Sundry Print Report

Well Name: BLUE KRAIT 23-14 FED Well Location: T24S / R33E / SEC 23 / County or Parish/State: LEA /

Sundry ID: 2689828

Type of Action: Variance

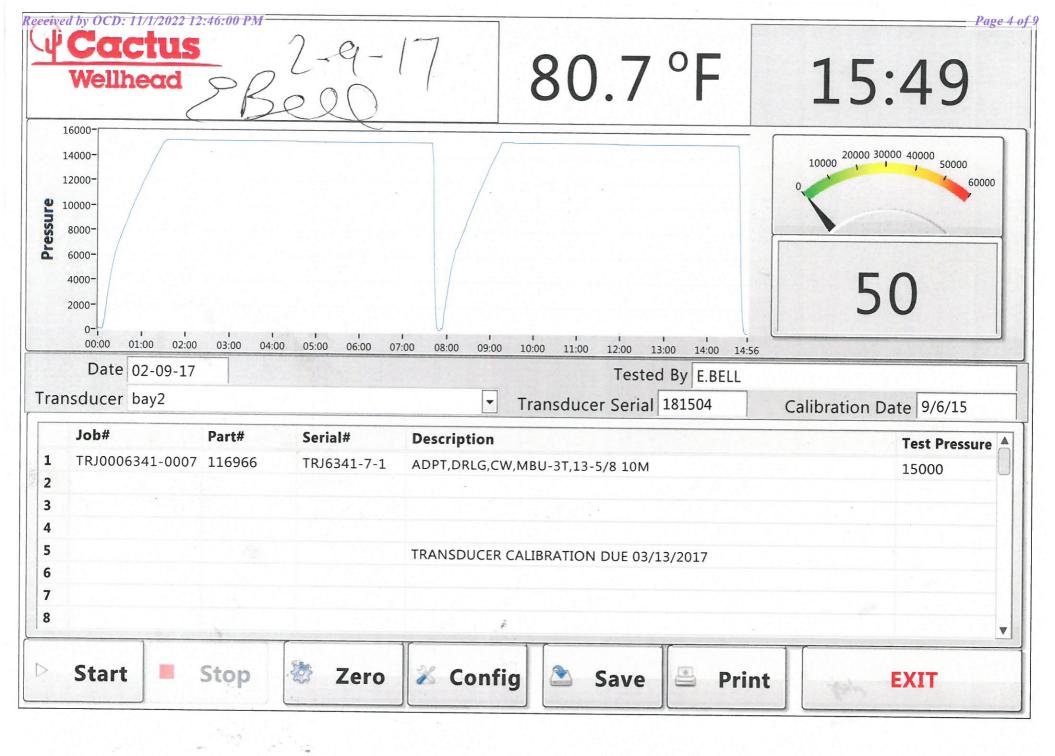
Devon Energy requests to only test BOP connection breaks after drilling out of surface casing and while skidding between wells which conforms to API Standard 53 and industry standards. This test will include the Top Pipe Rams, HCR, Kill Line Check Valve, QDC (quick disconnect to wellhead) and Shell of the 10M BOPE to 5M for 10 minutes. If a break to the flex hose that runs to the choke manifold is required due to repositioning from a skid, the HCR will remain open during the shell test to include that additional break. The variance only pertains to intermediate hole-sections and no deeper than the Bone Springs Formation where 5M BOP tests are required. The initial BOP test will follow OOGO2.III.A.2.i, and subsequent tests following a skid will only test connections that are broken. The annular preventer will be tested to 100% working pressure. This variance will meet or exceed OOGO2.III.A.2.i per the following: Devon Energy will perform a full BOP test per OOGO2.III.A.2.i before drilling out of the intermediate casing string(s) and starting the production hole, before starting any hole section that requires a 10M test, before the expiration of the allotted 14-days for 5M intermediate batch drilling or when the drilling rig is fully mobilized to a new well pad, whichever is sooner. We will utilize a 200' TVD tolerance between intermediate shoes as the cutoff for a full BOP test. The BLM will be contacted 4hrs prior to a BOPE test. The BLM will be notified if and when a well control event is encountered. Break test will be a 14 day interval and not a 30 day full BOPE test interval. If in the event break testing is not utilized, then a full BOPE test would be conducted.

- 1. Well Control Response:
- 1. Primary barrier remains fluid
- 2. In the event of an influx due to being underbalanced and after a realized gain or flow, the order of closing BOPE is as follows:
 - a) Annular first
 - b) If annular were to not hold, Upper pipe rams second (which were tested on the skid BOP test)
 - c) If the Upper Pipe Rams were to not hold, Lower Pipe Rams would be third

All Previous COAs Still Apply. Variance request procedure is approved as written, please see below general conditions for variance.

- BOPE Break Testing is ONLY permitted for 5M BOPE or less.
- BOPE Break Testing is NOT permitted to drilling the production hole section.
- While in transfer between wells, the BOPE shall be secured by the hydraulic carrier or cradle.
